Department of Environmental Quality

Re: WQ: CAS: Variance Approval: 248-22-000815-VAR: 16790 Casper Drive; T.20S; R.10E; Sec. 26AD; Tax Lot 2900; Lot 10, Block 10 Oregon Water Wonderland Unit No 1, 0.96 Acres; Deschutes County.

Schedule A – Rick & Nan Arnold
Variance Report - Special Conditions
T 20S, R 10E, WM, Sec: 26AD, TL 2900

Schedule B – Rick & Nan Arnold
Variance Report – Approved Plans
T 20S, R 10E, WM, Sec: 26AD, TL 2900

Figure 3. Modified Bottomless Sand Filter Section

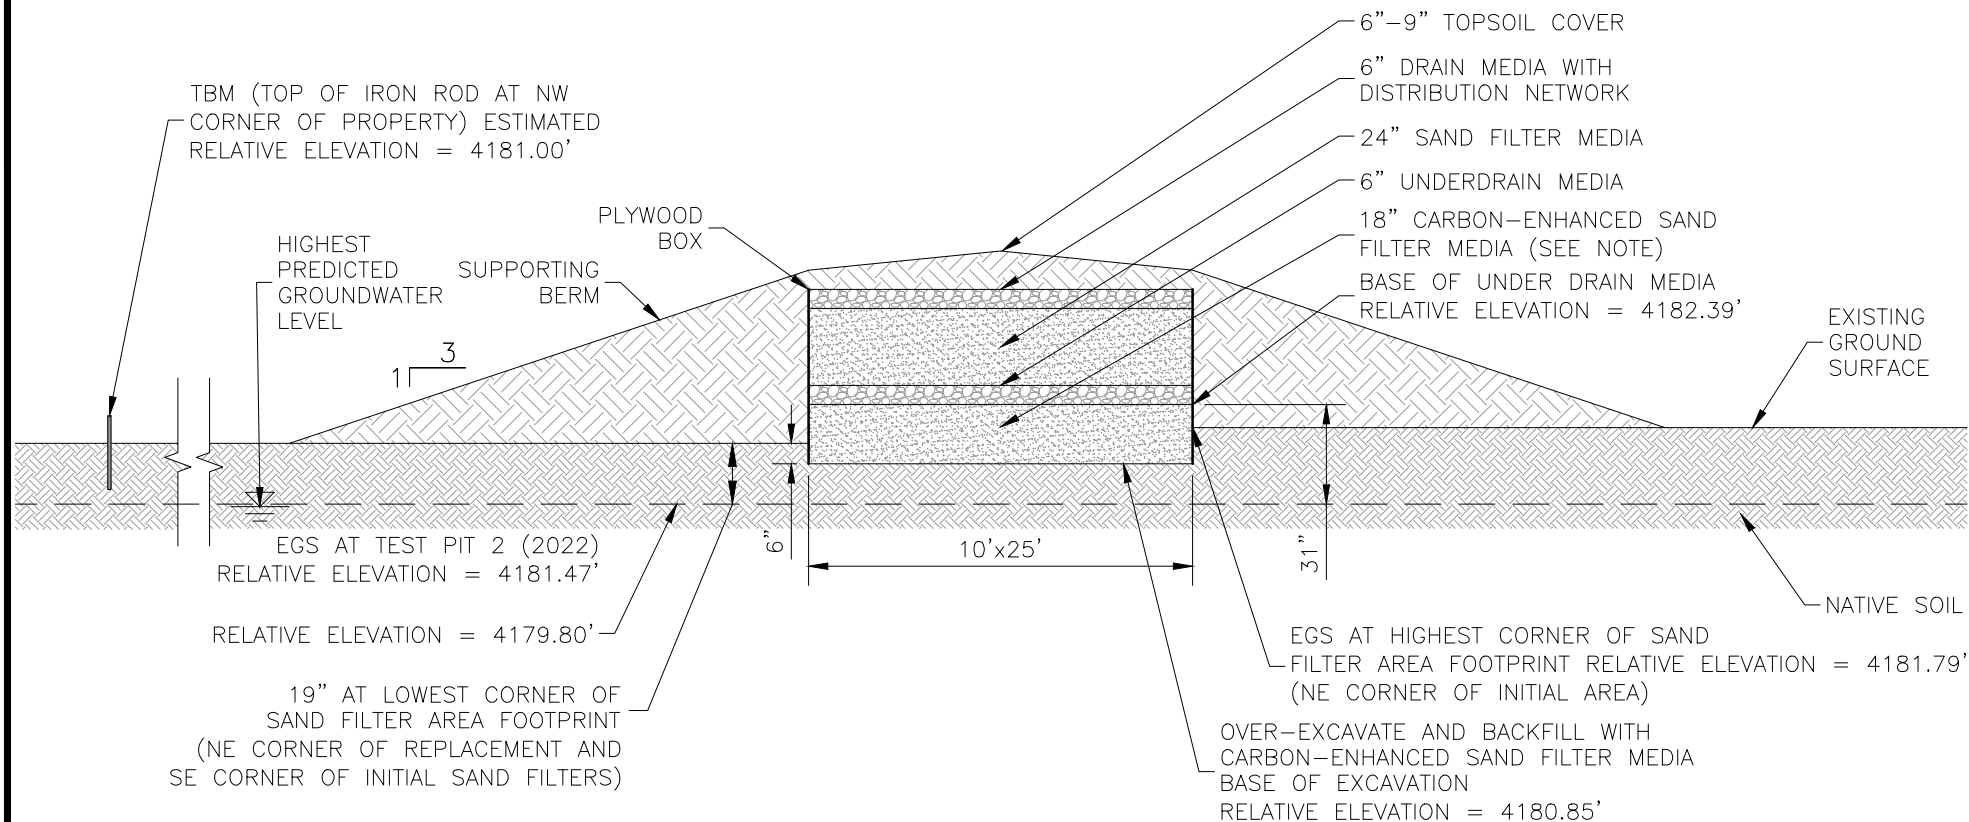
- Pre-treated effluent from the AX20N-Mode 3B unit (proposed w/o UV disinfection) discharging into a 250 square foot bottomless sand filter with an additional 18 inches of carbon enhanced sand filter media (embedded 6 inches) placed below the filter to meet or exceed the minimum 24-inch separation requirement for the reduction of fecal coliform, the proposed system will meet or exceed Treatment Standard 2 criteria. Note: The bottomless sand filter is assumed to meet treatment standard 2 criteria independently of the ATT, which is why UV disinfection is not included in the proposal.

The proposal is to overcome the site limitations by installing an Orenco® AdvanTex AX20N-Mode 3B Alternative Treatment Technology System followed by a 250 sq. ft. elevated reduced sized Bottomless Sand Filter system constructed on an 18-inch bed of carbon enhanced sand filter media embedded at least 6 inches into the native soil. It is expected that the highest level of groundwater within the lowest point of the sand filter areas will come to 19 inches bgs. The proposal seeks to overcome this limitation by providing additional carbon enhanced sand filter media, thus adding an additional 7 inches of vertical separation and providing a total 31-inch separation to the shallowest predicted groundwater depth. The rest of the sand filter will be “conventional” from there up, consisting of 6 inches of underdrain media, 24 inches of sand filter media, 6 inches of drain media (with the distribution laterals), filter fabric, and 6 to 9 inches deep of final backfill on top. The sand filter is proposed to be contained within a supporting berm with a slope no steeper than 3:1 (3 feet horizontal for every 1 foot vertical).

4. To enhance nitrogen removal, a carbon augmentation source consisting of 25 percent wood (half-coarse chips, half-fine sawdust), must be blended/mixed with the additional sand filter media placed to meet the minimum separation distance to groundwater. The carbon enhanced bottomless sand filter construction must follow the media and lysimeter installation guide as prepared by Brian Rabe in Appendix F of the variance proposal materials. Lysimeters must also be installed as per the approved plans so that samples may be taken to assess nitrogen reduction through the carbon enhanced layer. Sampling shall be allowed by current and future property owners periodically to ensure the performance of the system.
